# **Identification of Producibility Inhibitors in Standard NAVSEA Ship Design Practices**

U.S. DEPARTMENT OF TRANSPORTATION  
Maritime Administration and U.S. Navy

**Newport News Shipbuilding**

**ITEM P-9**

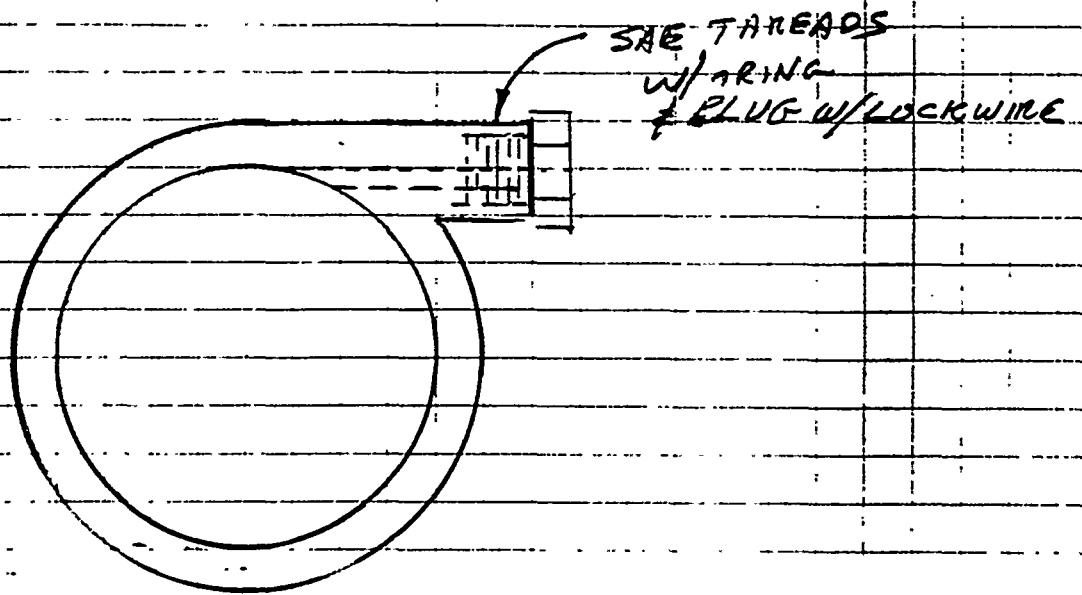
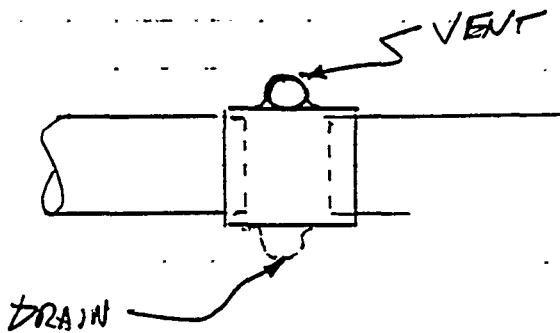
**PROBLEM STATEMENT:** The use of globe valves for high pressure and low pressure vent and drain systems is more expensive than the alternative discussed below.

**ADDITIONAL COMMENT:** The simple fitting shown in the accompanying sketch would be much less expensive to manufacture and install than globe valves.

**PROPOSED SOLUTION:** Develop a low pressure tangential vent and drain fitting similar to the high pressure vent and drain fittings used on submarine hydraulic systems, and use these type fittings in all fluid systems..

MODIFIED 2" DK DRAIN W/4" SEAL

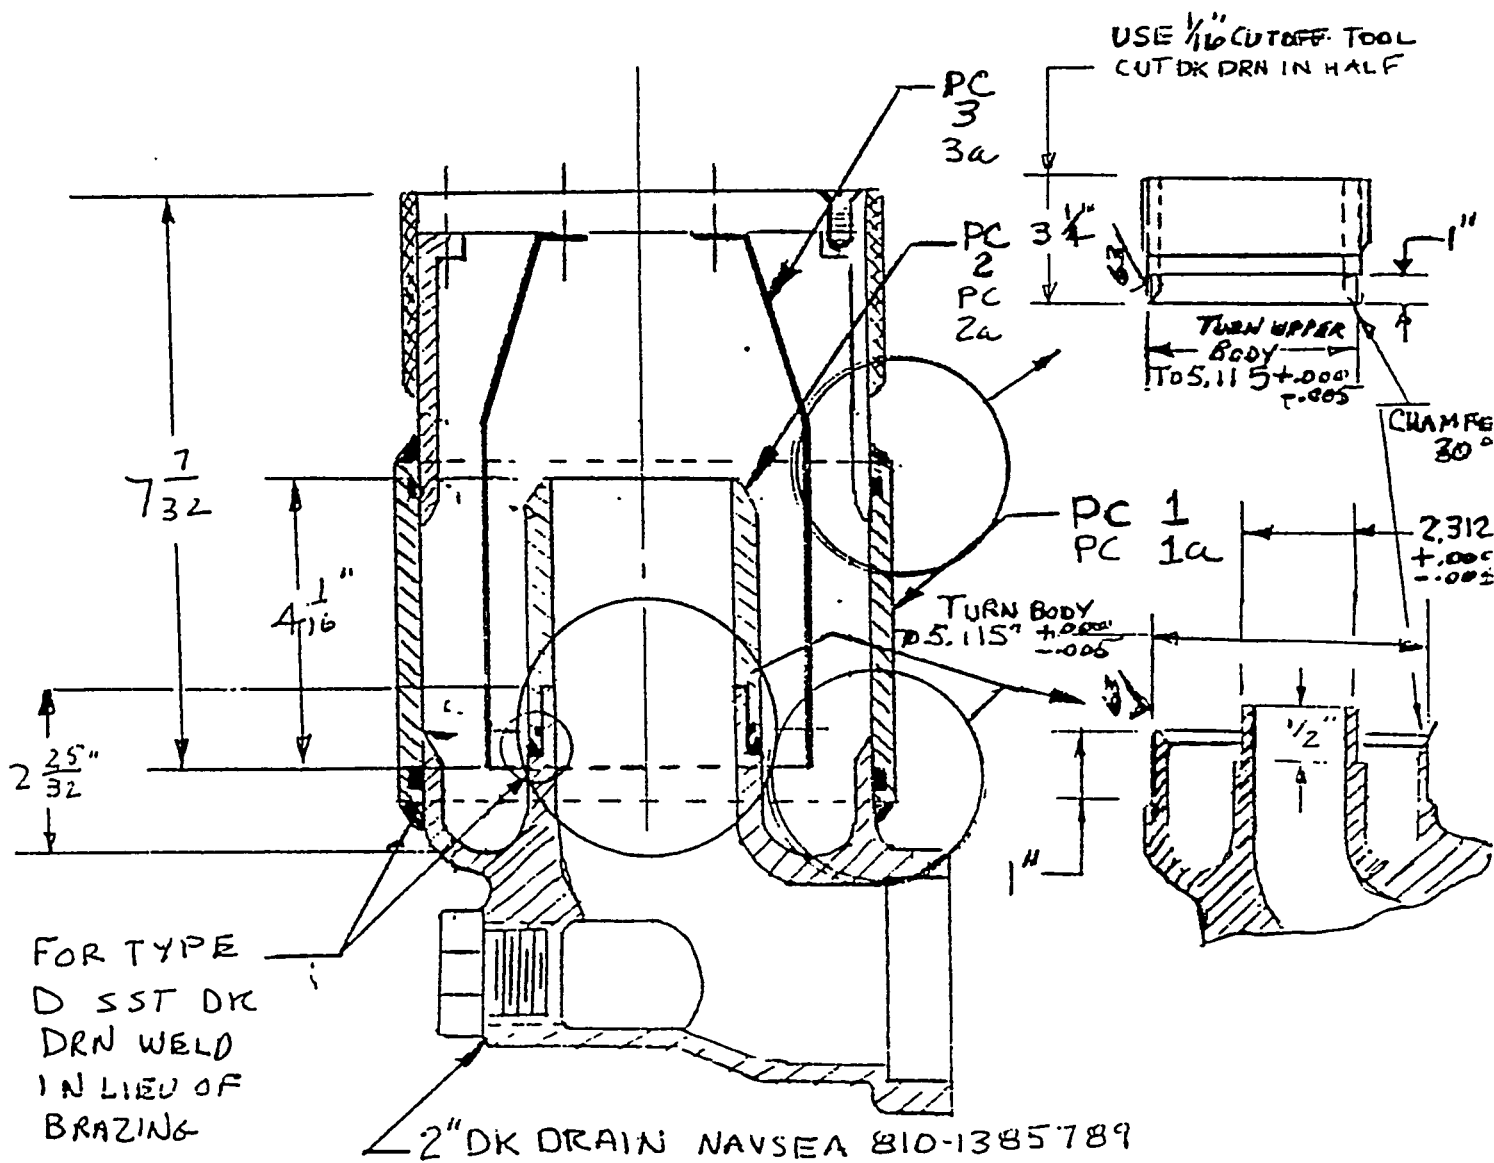
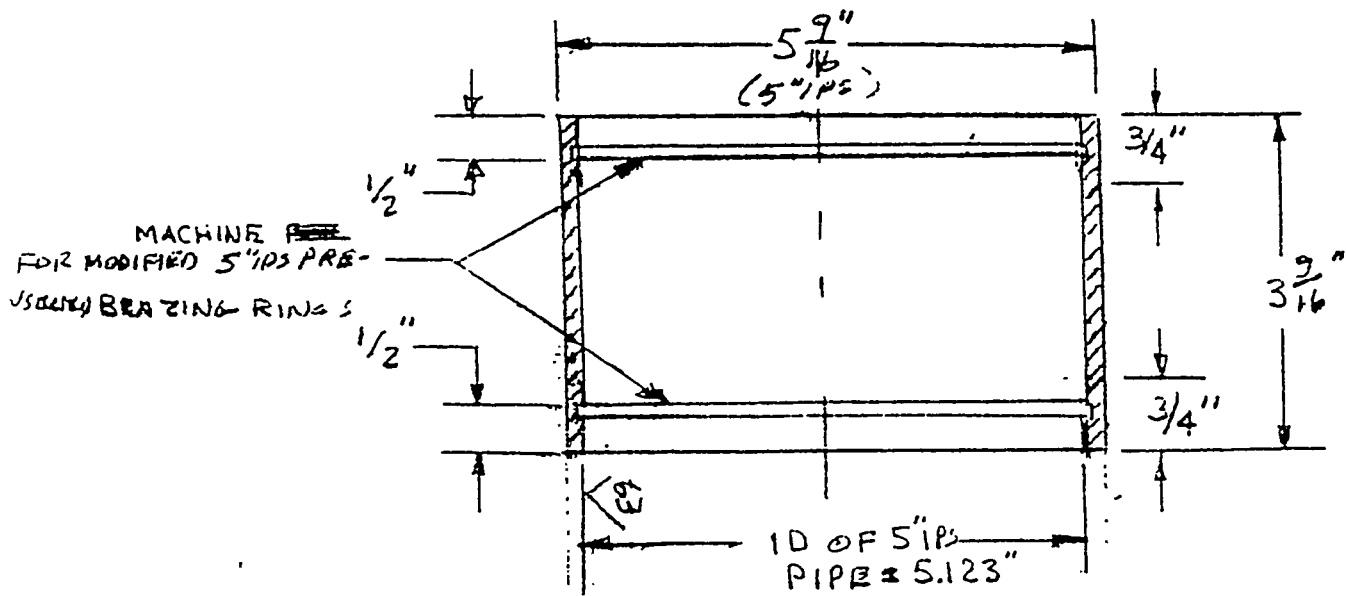
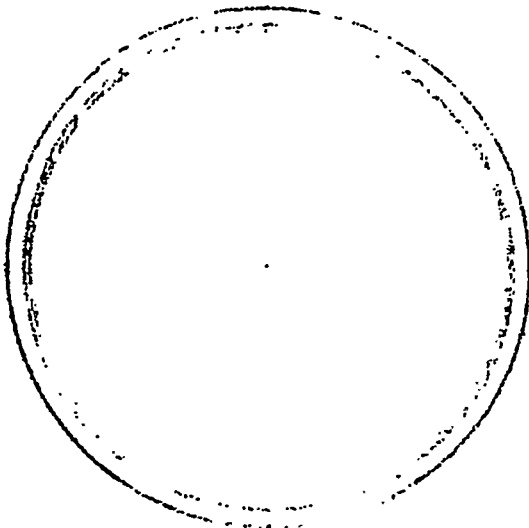
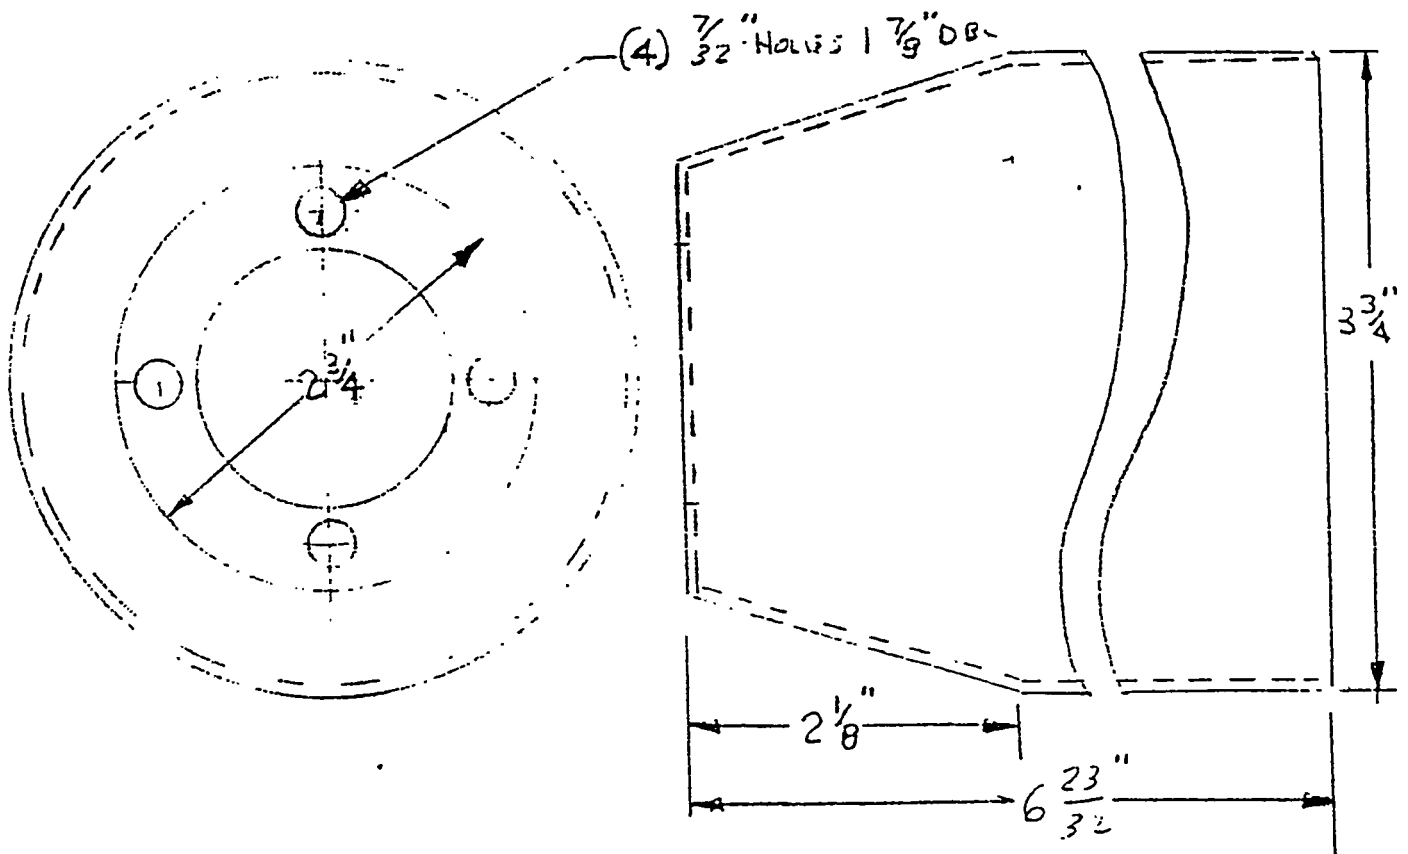
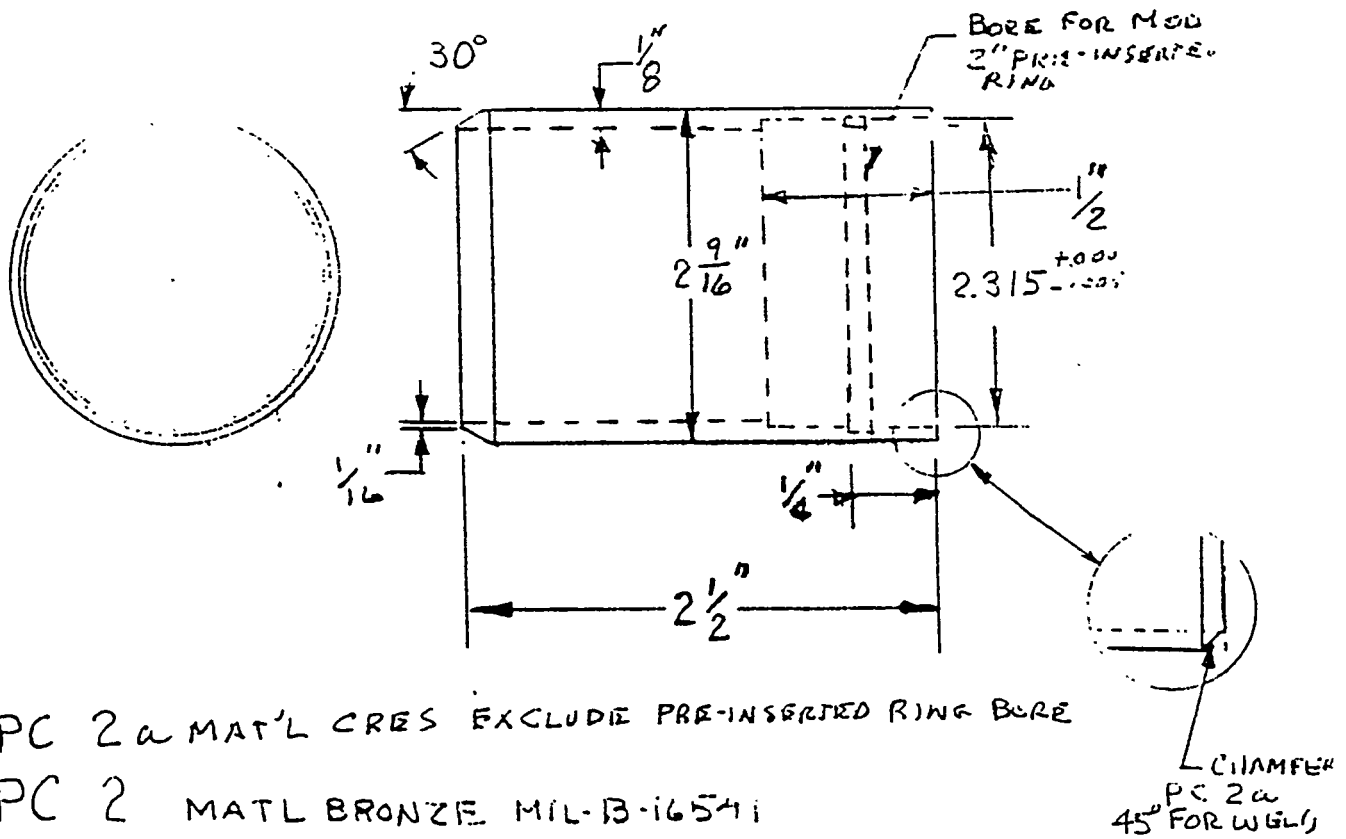
**PROBLEM STATEMENT:** "P" traps now have to be added in drain rings for CPS systems. These have to be oriented fore and aft, which affects design and installation.

**ADDITIONAL COMMENT:** Design time and installation time will be reduced. See attached sketch for proposed changes.

**PROPOSED SOLUTION:** Modify existing deck drains or manufacture new ones to suit 4" seals.
